CAPRICORN MUNICIPAL DEVELOPMENT GUIDELINES

2024 MEETING 1 MINUTES

Date and Time: 1st February 2024 at 11:00 am

CMDG-R-101: under road 900mm – 100/150mm, 1000mm – 225/300mm

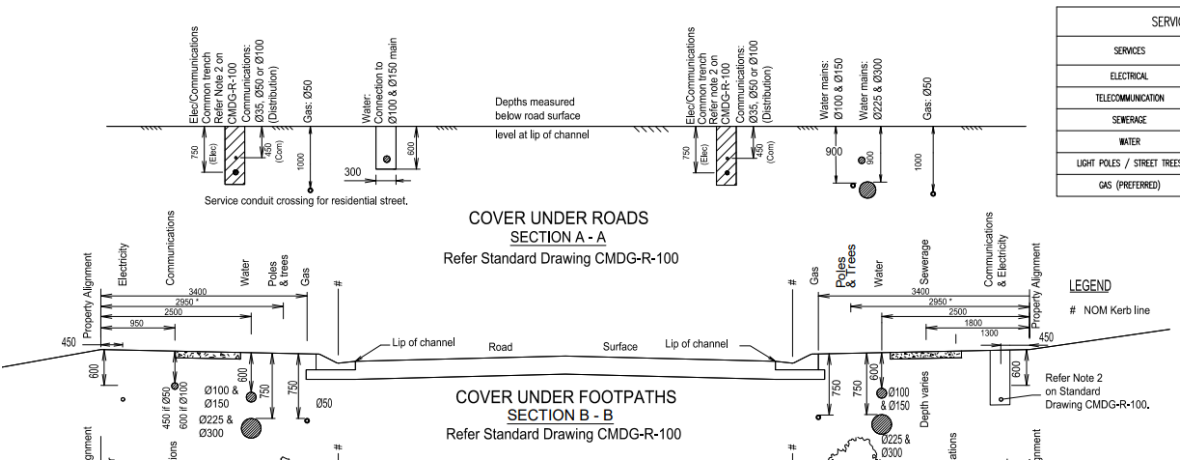
It has been noted that CMDG contains different depths for watermains across the drawings and specifications. There is also some ambiguity between whether a driveway counts as vehicular loading.

For discussion.

Comments from MRC:

- The depths don't match TMR minimum requirements – should this be considered to achieve parity with TMR requirements. Would help LGA's.
- For vertical clearances of services minimum for gas is usually 150mm; is this to be maintained? Perhaps a clearer note to stipulate this.

- Don't agree with the variation of depth for gas services under roadway to different levels especially where it goes under power to a depth of 1m this makes accessing it during a leak or where someone damages the gas pipe more difficult, much prefer no low spots where condensation or condensate can build up.

It was discussed that the specification would override the drawings.

'Not in a roadway (e.g. driveway)' to be amended on Table D11.10.01. MCE to check PVC material type and ensure all materials are accounted for.

Drawing CMDG-R-101 to be updated to remove sizing information.

Discussions with LSC about additional information in relation to watermain depths of cover concluded with recommendation to remove cover information and refer to D11.

TBC. Recommend simplification or removal of drawing.
